Villanova CICD CARE Group

TOWNSHIP OF RADNOR Villanova CICD CARE Group Minutes of the Meeting of January 5, 2017

TOWNSHIP OF RADNOR LIGHTING ASSESSMENT FOR VILLANOVA UNIVERSITY'S WEST LANCASTER AVENUE PARKING FACILITY RADNOR TOWNSHIP, PA BY

APPENDIX: PHOTOS

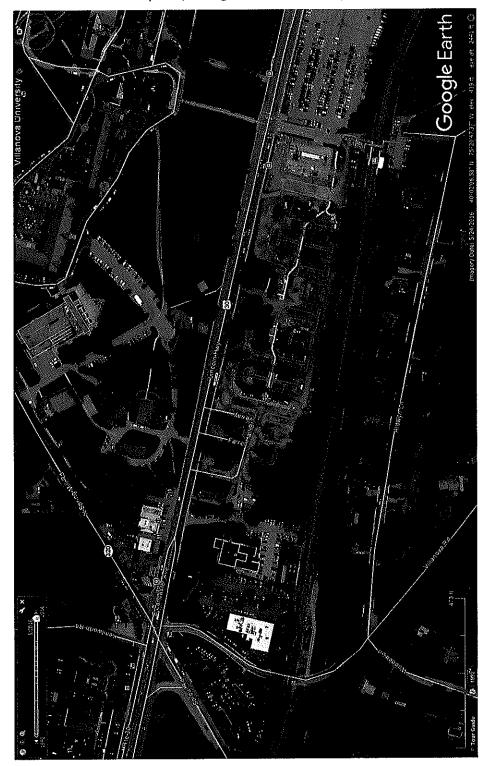
- i. LED light source is very directional and the installed luminaires have the LED array installed in the top of the fixture, shining downward on angles, providing a specific light pattern. The installed luminaires included cut-off optics, which means to direct the light onto the parking surface in a desirable pattern. During the site visit this was confirmed, however the light from the LED array reflected off the smooth, angled, interior surfaces of the luminaire's acrylic lens, which was clearly observed & perceived as bright while standing at a distance of approximately 30 feet from the base of the fixture. It is our opinion that this reflected light, which may be inferred by the residents of Alwyn Lane as being directly from the light source (the LED array), however at the distance to their properties, this distinction was not discernable. Documentation has been received since the site meeting which notes that full cut off shielding has been installed on (5) five fixtures in close proximity to Aldwyn Lane, & a 2" shielding strip has been installed on (33) thirty-three of the other WLAPF fixtures (and will be installed on (4) four fixtures yet to be installed), and (9) nine fixtures along Lancaster Avenue remain with no additional shielding.

- 1. Submitted WLAPF luminaire does not satisfy the section of §280:105 stating "some type of glare shielding device" as required by the township Zoning ordinance; either a full cutoff shield or 2" shielding strip has been installed on several luminaires, however all are required to have shielding.
- 2. WLAPF luminaire has a smooth, clear acrylic lens, which is reflecting the light horizontally, & thus does not satisfy the second part of SALDO requirement §255:29 "[...] nor shall any high-brightness surface of the luminaires be visible from neighboring residential properties or from a public street."
- 3. Basketball court lighting near Delurey Hall; though this is an existing condition, it is suggested that these fixtures be modified (i.e., reoriented, shielded, et cetera) to provide relief from light spill to adjacent properties.

- WLAPF Luminaires: Manufactures have glare controls, i.e., frosted glass or films, which are
 options. These might be retrofitted in each existing fixture to reduce the highly reflective
 smooth surface of the fixture lens to meet the ordinance. Existing fixtures on VU campus
 proper have a diffused lens, which achieves a similar affect (see Appendix)

Site photo, Basketball court lighting at Delurey Hall

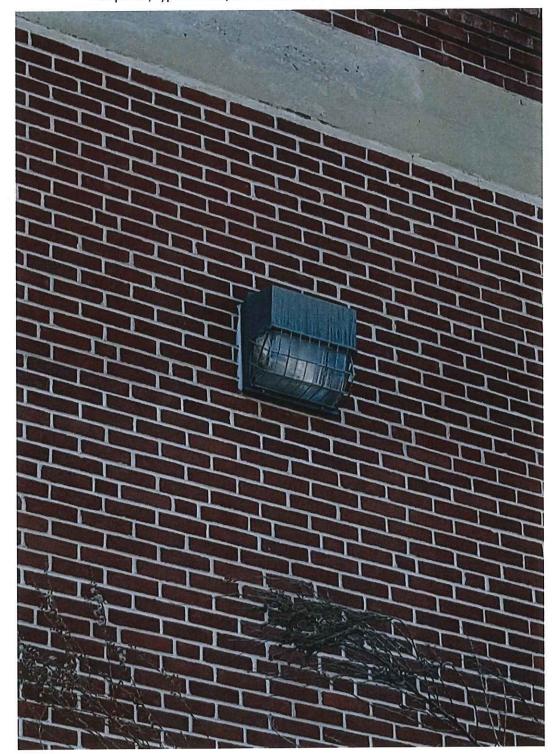
ii. There is also university exterior basketball court lighting near Delurey Hall, which appears to utilize a metal halide light source, that is clearly observable from the neighboring residences, presumably due to the removal of trees and/or vegetation prior to &/or during the construction of the WLAPF.

- 1. Mercury vapor wall mounted luminaire and HID wall fixtures on restaurant across Lancaster Avenue.
- 2. Wall mounted high pressure sodium luminaire on a banking facility.
- 3. Wall mounted high pressure sodium fixture on the PECO Building.
- 4. Pole mounted high pressure sodium fixtures at SEPTA NHSL Station.
- 5. Pole mounted high pressure sodium street light across Lancaster Avenue.

- 5. The Non-University Luminaires: These luminaires are not new and may not be addressable by the township unless they have been installed under a recent permit, or the township has another means of redress at their discretion. Each of the buildings observed having exterior lighting could upgrade, and possibly even be compensated financially for doing so by utility rebate programs which may available; cost savings on reduced electrical usage may also provide incentive to do so. These rebate programs reimburse the owners for upgrading exterior lighting to LED energy efficient luminaires and will require glare control, Dark Sky approved luminaires.
